Docket Number:	11-AFC-01C
Project Title:	Pio Pico Energy Center - Compliance
TN #:	206443
Document Title:	Pio Pico Energy Center Response to Wastewater Tank PTA Data Requests
Description:	N/A
Filer:	Dale Rundquist
Organization:	Sierra Research
Submitter Role:	Applicant Consultant
Submission Date:	10/28/2015 10:19:14 AM
Docketed Date:	10/28/2015

Subject: Pio Pico Energy Center Response to Data Request

Figure 1. GEP 5L Area of Influence from Clarifiers and Water Tanks

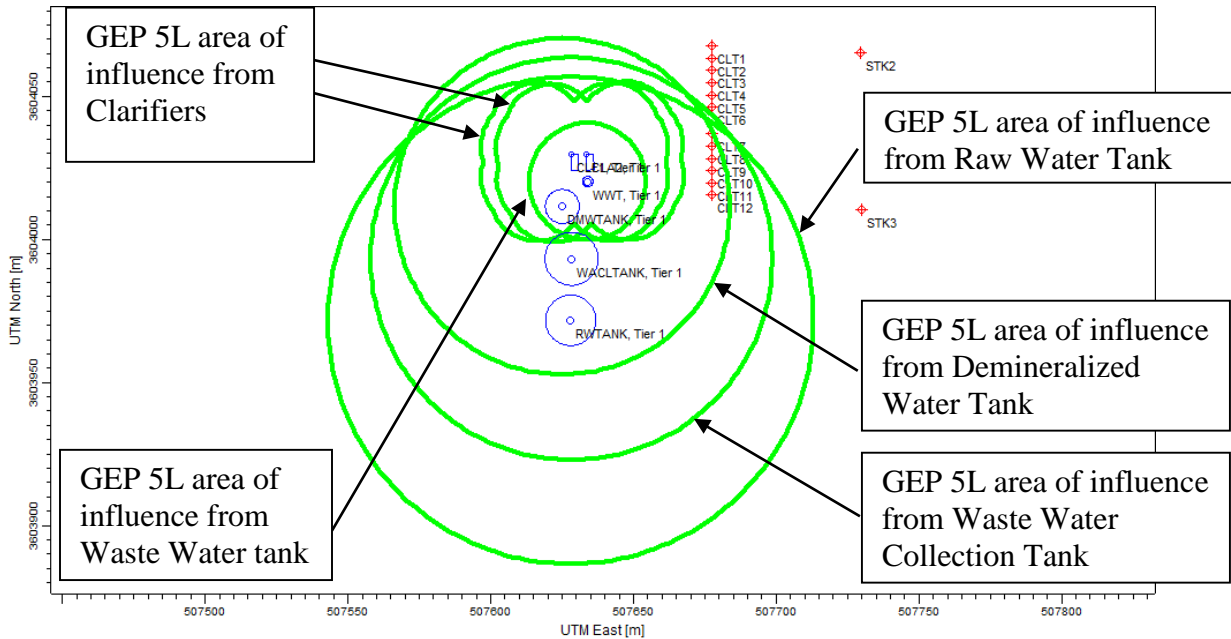
- 1. What is the basis for concluding that the tank dimension changes would not affect the stack plume?*

2. Provide documentation that the turbine stack plumes would be unaffected by the new structure(s), or please redo the plume velocity analysis including the stacks (and any updated data/structures from the table below).

3. *Why were structures #2 and #4 excluded from the modeling analysis and why was structure #3 excluded from the petition to amend (PTA)?*

Figure 1 shows the areas of influence of the waste water tank and the clarifiers in relation to the nearest stacks. The turbine stacks are well outside the areas of influence of the structures. As a result, AERMOD ignores wake effects from these structures on dispersion from the turbine stacks. Because these structures are ignored when modeling impacts from the turbine stacks, changes in the dimensions of these structures will not affect the turbine modeling results.

Response: Please see response to Data Request 1.

Structures #2 and #4 were excluded from the water tank PTA modeling analysis because they were not included in the original modeling analysis. They were excluded from the original modeling analysis because they are too far away from the cooling system to be included in the modeling. Current guidance is to exclude structures that are more than 5L distant from the stack, where L is the lesser of the structure height and projected width.¹ For the FWST, the 5L distance is 60 feet; for the clarifiers, the 5L distance is 101 feet. The distance from the nearest element of the cooling system to either structure is greater than the 5L distance, and the structures can therefore be disregarded for modeling purposes. See Figure 1.
